Wheelhouse visibility, escape,
accommodation and personal safety

Wheelhouse visibility, escape, accommodation
and personal safety

Proposed to delete Chapter 3 in the current NSCV C1

Figure 2 — Field of vision for vessels ≥24m from the operating station (clause 3.4)

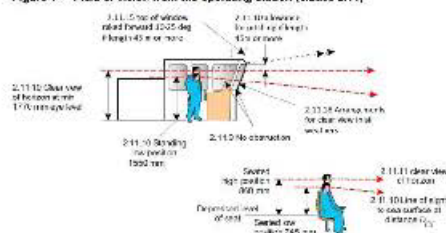
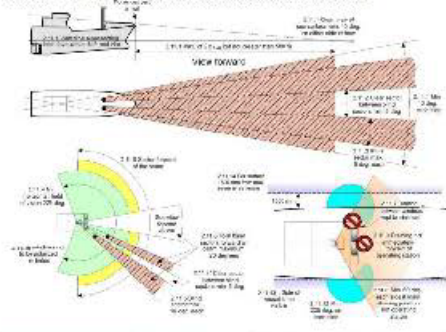
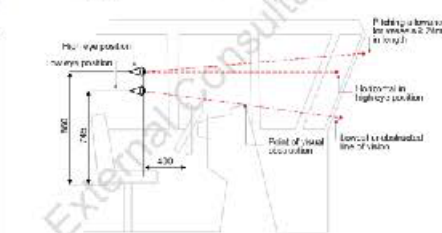
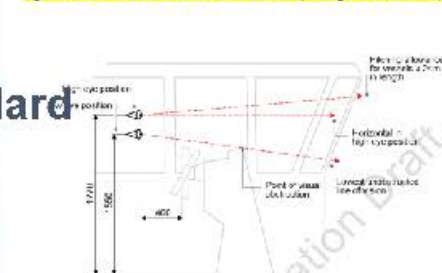
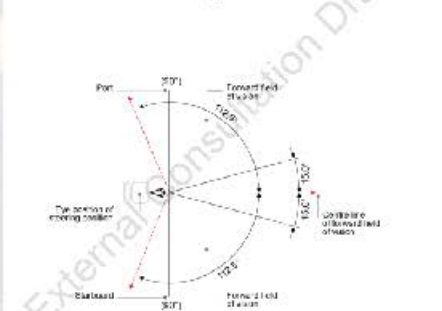
The proposed change seeks to make minimal technical changes. The main driver of change for the operating stations was to simplify the standard and make it easier to understand and apply.

Item	Criteria <24m Vessels	Criteria ≥24m Vessels
View forward from operating position		
3.4.1	The view of the sea surface from the operating position must not be obscured for a distance of more than: <ol style="list-style-type: none"> $L_m \leq 12.5$ m four times the vessel's measured length $L_m > 12.5$ m to ≤ 25 m 50 m $L_m > 25$ m twice the vessel's measured length The view must be clear for at least 10° on either side of the bow under all conditions of draft, trim and deck cargo (see figure 2).	The view of the sea surface from the operating position must not be obscured for a distance of more than: <ol style="list-style-type: none"> $L_m \leq 12.5$ m four times the vessel's measured length $L_m > 12.5$ m to ≤ 25 m 50 m $L_m > 25$ m twice the vessel's measured length The view must be clear for at least 10° on either side of the bow under all conditions of draft, trim and deck cargo (see figure 2).

3.4.2	Outside the clear sector of visibility from the operating position throughout the horizontal arc measured from 112.5° to port and 112.5° to starboard, obstructions must be kept to a minimum such that normal movements of the operator's head will permit unobstructed visibility (see figure 2).	The clear sectors between blind sectors must be at least 5°.

3.5.3	Not applicable.	Framing between operating compartment windows must not be installed immediately forward of any operating position.

Figure 7 — Dimensions of steps in stairways

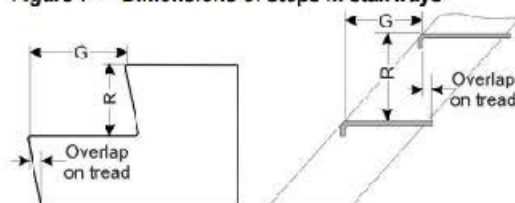
- No proposed changes for less than 24 m vessels.
- For a vessel between 24 m to 35 m, a minor proposed increase to 1.98 m (or 80mm) has been included.
- Vessels of at least 35 m have a proposed increase in headroom to 2.03 m (or 130mm) and are now MLC compliant and vessels at least 24 m in length being sustainably equivalent to MLC.
- AMSA understands the minimum clear height above stairs to be a prevalent issue based on injury data and feedback. We have moved this within the standard, so all headroom data is in the same location.

- The clear height above the top of each stair that forms a stairway must be:
 - For a vessel less than 35m measured length – minimum of 2m; and
 - For a vessel at least 35m measured length – minimum 2.08m.

Figure B1 Exit and escape signs

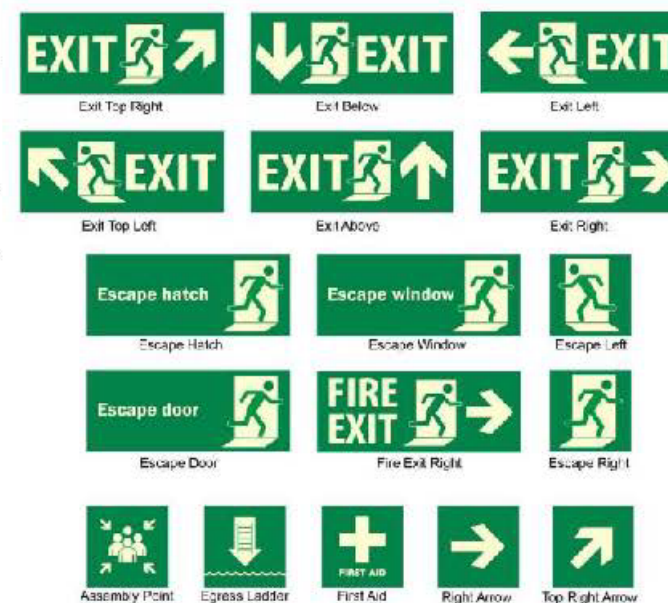
Improving escape marking (both signage and lighting) is a major component of the proposed C1 standard.

Annex B provides basic information for small-to-medium operators to be able to purchase the correct escape markings. We have also provided some additional compliance pathways via ISO and Australia standards to increase flexibility etc.

- 1) Signs and markings must be the minimum following sizes set out in Table B1 and pictorially the same or equivalent to figure B1.
- 2) Alternatively, compliance with the ISO 24409 series of standards, IMO Resolution A.1116(30) or AS1319, Safety Signs for the Occupational Environment is a deemed to satisfy solution.
- 3) Must be maintained, serviced, and replaced in accordance with manufacturers recommendations.

Table 17 — Types of escapes from accommodation spaces

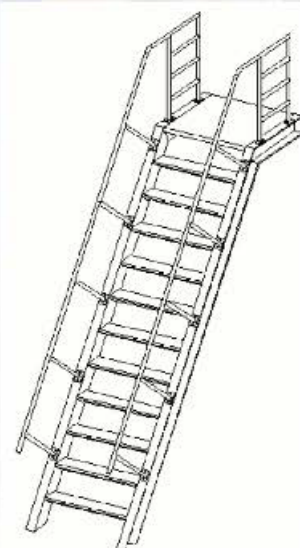
We have proposed an increase in some low-capacity ladders, like ones you would commonly see on a flybridge, or even perhaps a tug or large naval ship. The existing standard only allows these types of ladders up to 1.5 m, which is not even the tween deck height of most vessels.

Nominal number of persons within the space The nominal number of persons in the space is: - for Class 1: the sum of the number of passengers and 2/3 number of crew; and - for Class 2 and 3: the sum of the number of passengers and the number of crew.	Primary access	Alternative escapes
0 to 4	Low-capacity acceptable, rung ladders limited to use by crew only and not more than 2.2 m high	Low-capacity acceptable
0 to 4	Low capacity acceptable, ladders limited to between 60 and 75 degrees with handrails either side and not more than 2.2 m high	Low-capacity acceptable
5 to 12	Low-capacity door, stairway, passageway or walkway acceptable (but not rung ladder), step ladders limited to not more than 2.2 m high	Low-capacity acceptable

Figure 7 — Dimensions of steps in stairways

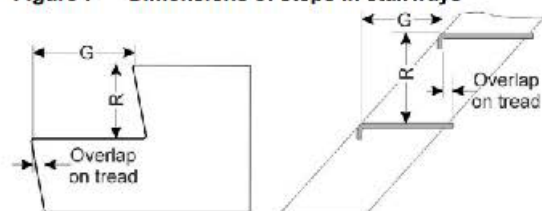
Very minor proposed changes to the dimensions of steps in stairways (based on updates to the NCC and AS).

Characteristic	Steps for high-capacity escapes (mm) (Based on NCC Vol 2 safe movement and access)	Steps for low-capacity escapes (mm) (Based on AS 1657-2018)	Spiral Steps (mm) (Based on NCC Vol 2 safe movement and access)	Preferred values (mm)
Rise (R)	115 to 190	130 to 225	140 to 220	190
Going (G)	240 to 355	215 to 355	210 to 370	275
Slope relations (2R + G)	550 Min 700 Max	540 Min 700 Max	590 Min 680 Max	625
Tread depth (min)	185	185	See NCC Vol 2 safe movement and access	n/a
Overlap on tread	≥ 30 if $G < 254$, 0 if $G \geq 254$			n/a

Figure 4 – No climb zone

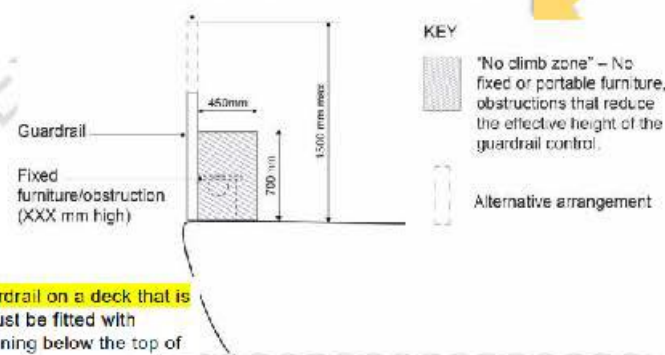
Introduction of a ‘No climb zone’ for class 1 passenger vessels on decks accessible by passengers less than 12 years old. We are keen to hear you feedback on this and improve the drafting of the provision to incorporate the above point.

Question 6 — You'd better make it easier to build ferries over 35m if you are proposing to limit the area available for seating per the 'no climb zone' proposal. Surely parents have some responsibility to supervise.

- (b) where a seat does not have an adequate backrest or support, adequate hand holds must be provided and seating or obstructions in the “no climb zone” must not reduce the height and performance of person overboard preventions mentioned in clause 6.4.

NOTE Seating may be placed in the no climb zone with increased guardrail height to ensure the performance requirements of 6.4 are maintained.

Answer — The 'no climb zone' proposal has two options. One of the options will not reduce seating capacity at all and just requires higher guardrails if seating is placed against guardrails.

Figure 11 — Pilot vessel uninterrupted, continuous safety rail system and clipping point illustration

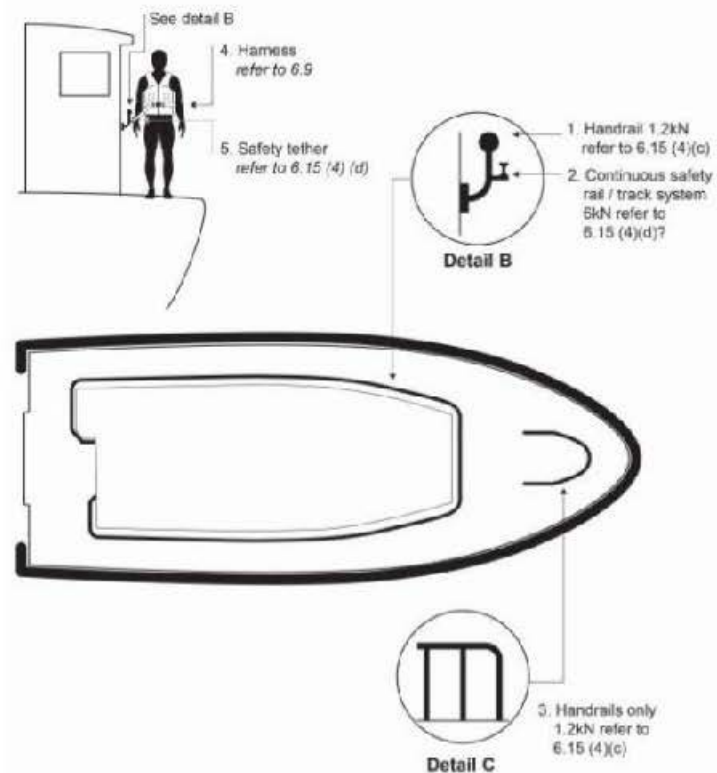
Continuous safety rail for pilot vessels—proposed to increase track system to 6kN and maintain 1.2kN for handrails.

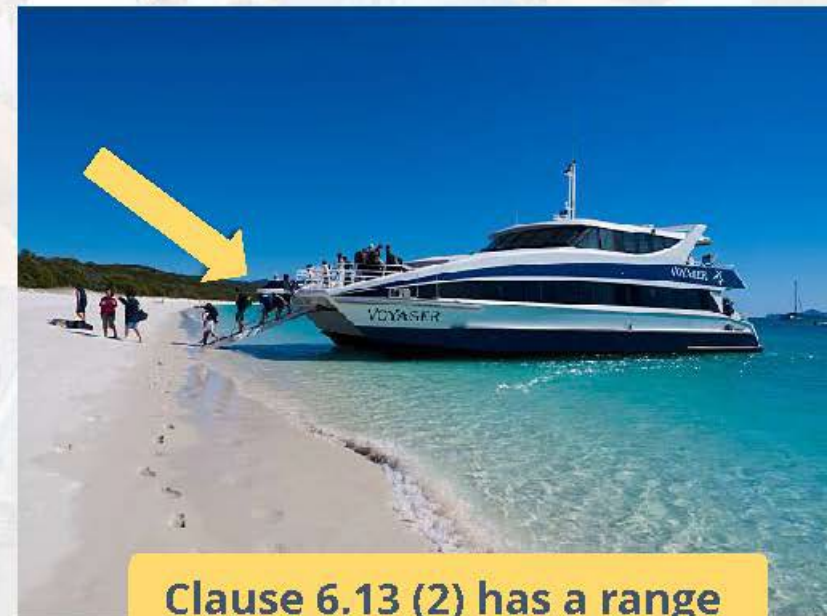
Vessel-supplied access and gangways are proposed to stay in the standard as they are a surveyed item.

**Clause 6.13 (2) has a range
compliance options**
